5 November 2021
Nuvis Landscape Architecture
RE: Sunset Reservoir, Pasadena

This Addendum to the 22 June 2021 report is to reflect the updated information provided. I have updated the count with three (3) additional trees and created a new list of nineteen (19) trees likely to be removed due to the new construction design (#Rxx). This Addendum should provide information on the questions raised regarding the tree recommendations. Each of these points contain views of the Plan Sheets with KJ comments and my responses for clarification.

ADDENDUM 3-17-22

This Addendum to the 22 June 2021 report is to reflect the updated information provided. It includes corrections to *Addendum 11-5-21* and replaces it. Comments in **bold** are corrections to *Addendum 11-5-21*.

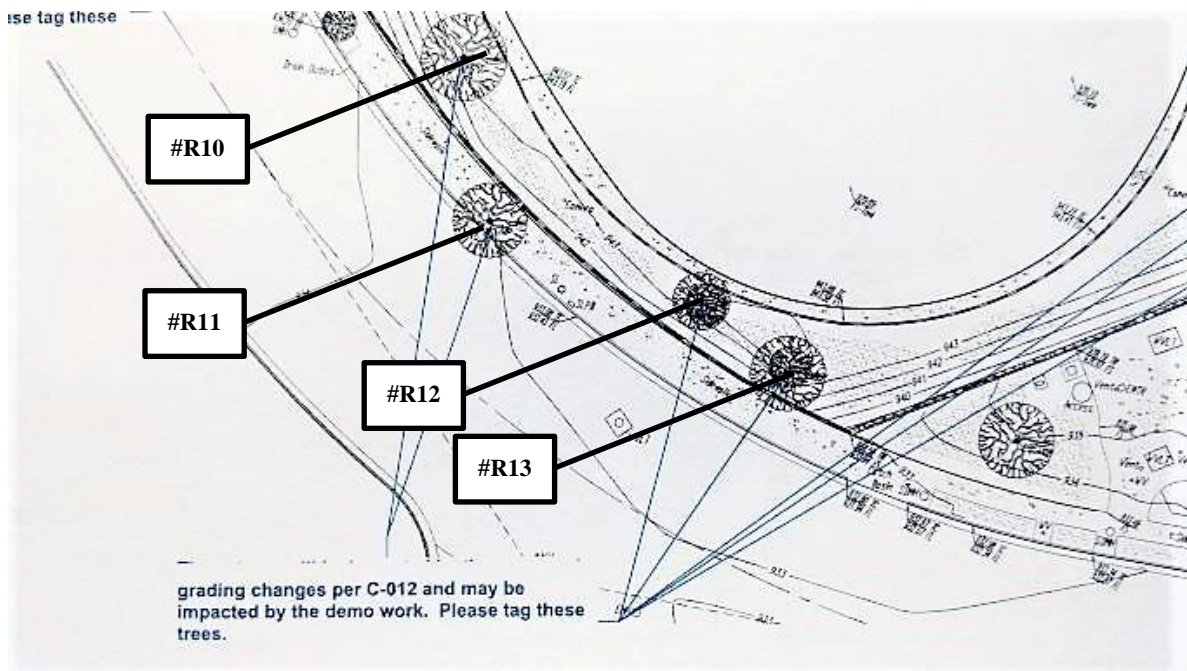
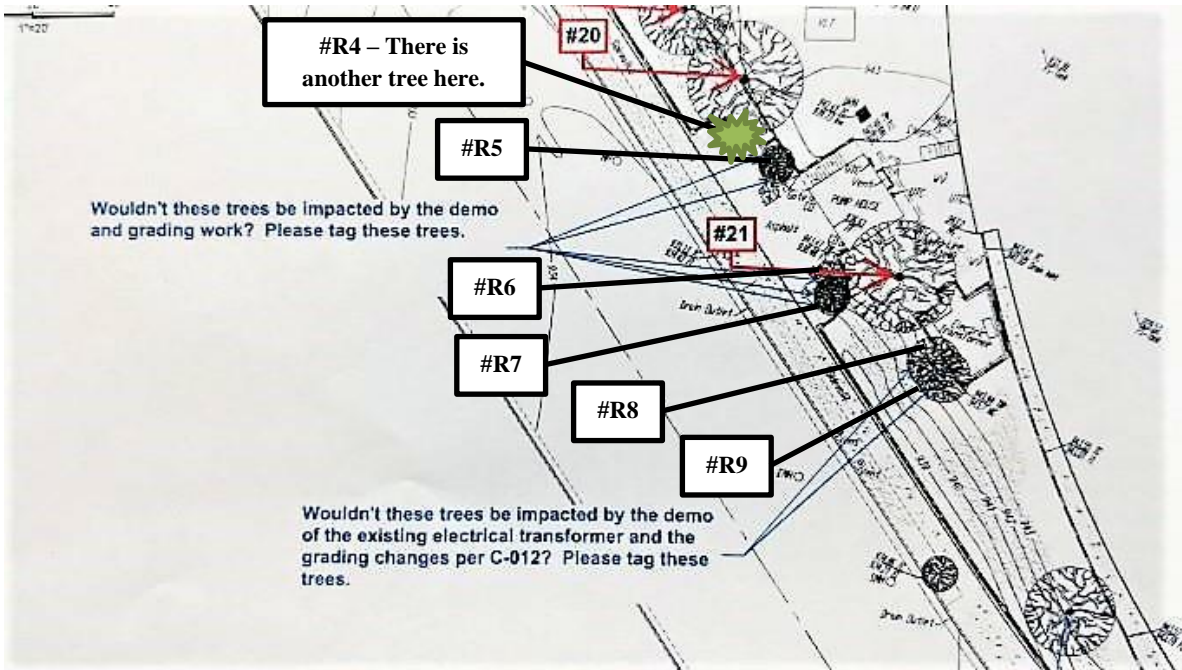
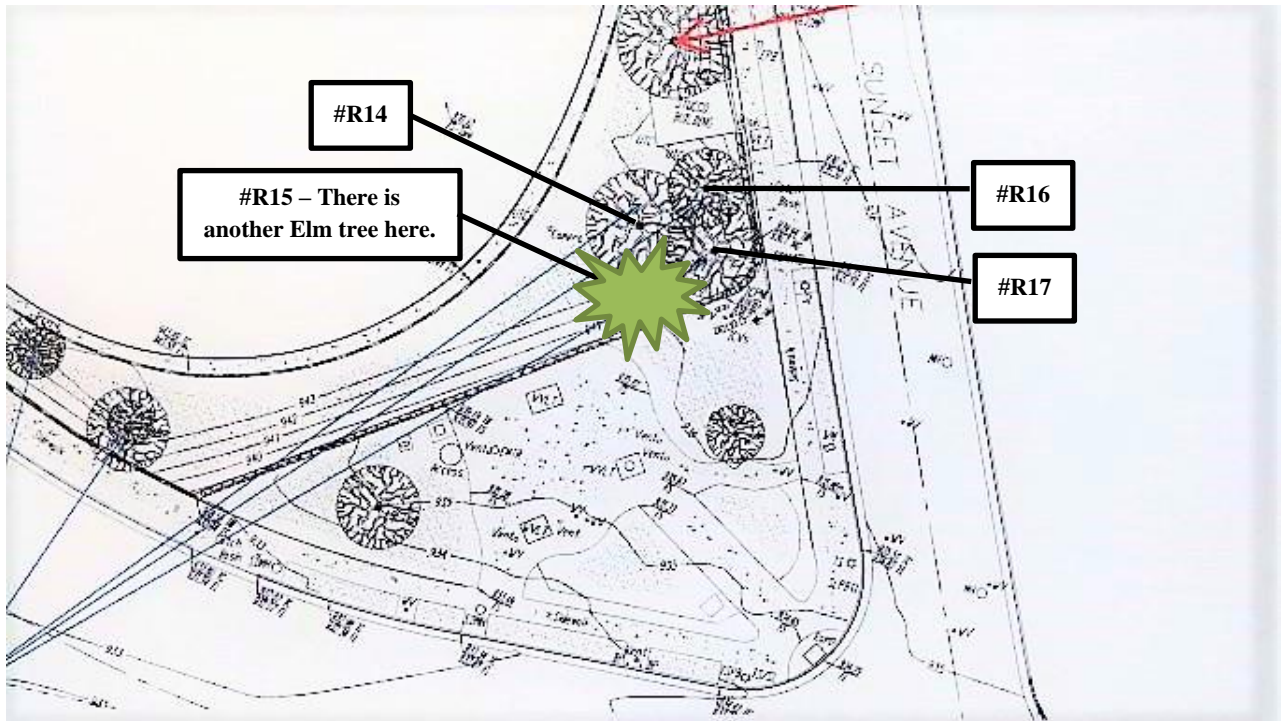
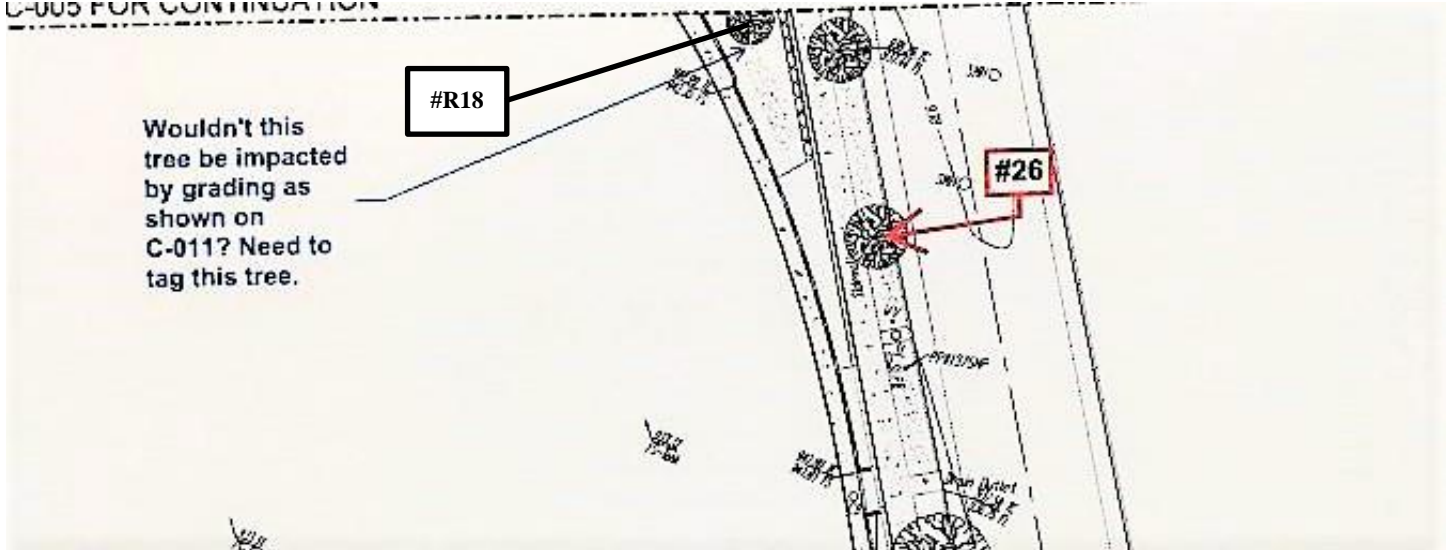
6. Sixteen (16) trees to be removed (Sheet C-006).

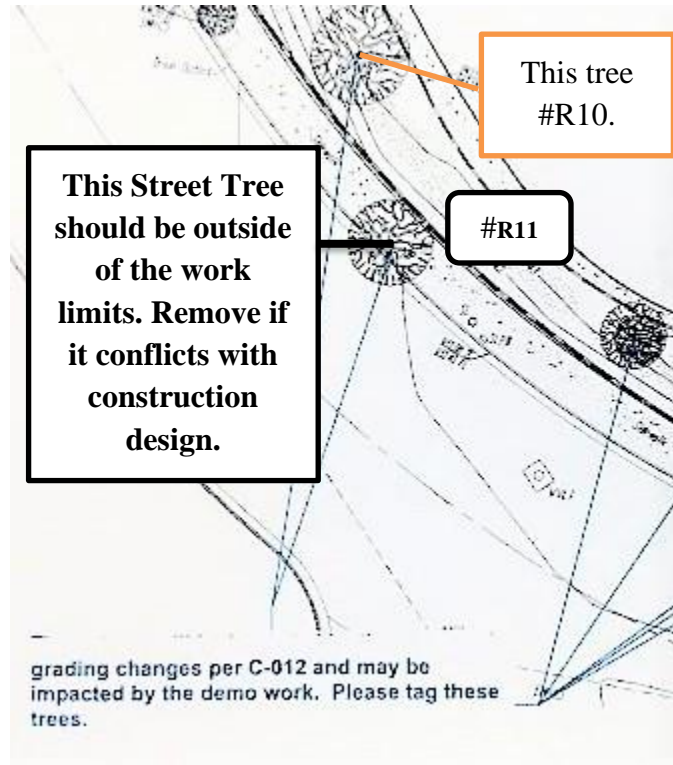
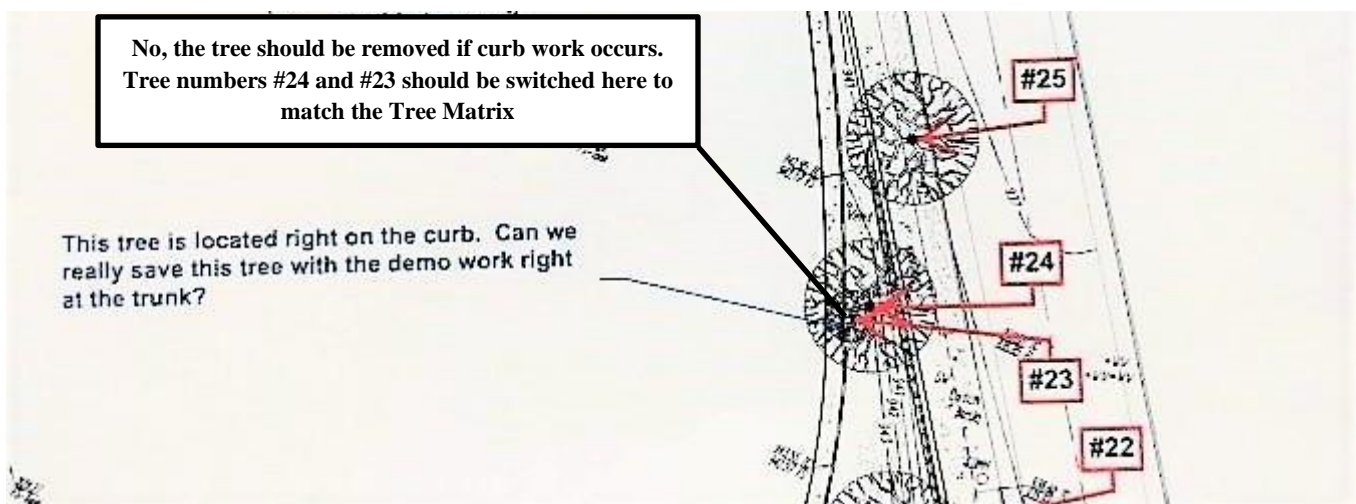
7. Comment on tagging Street Tree on Montana potentially impacted by demo work (Sheet C-006).

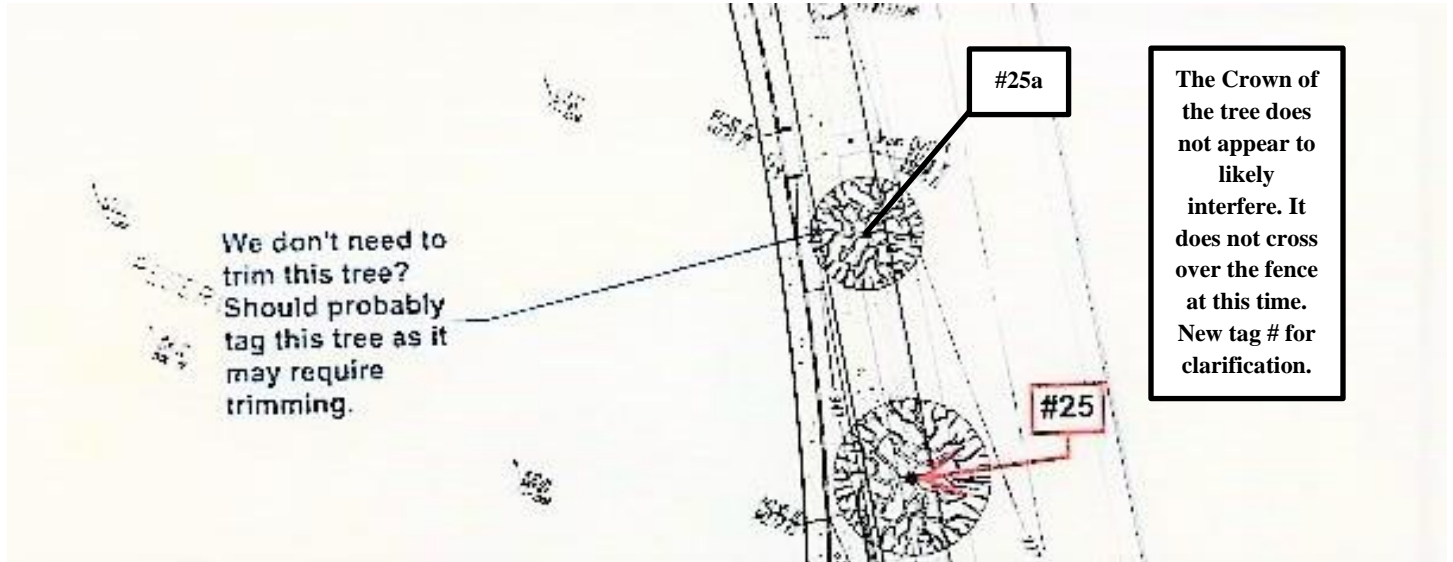
8. Comment on #24 impacted by demo work, and correct numbering (shown as #23 - Sheet C-006).

9. Comment on tagging Street Tree on Sunset potentially to be pruned (Sheet C-006).
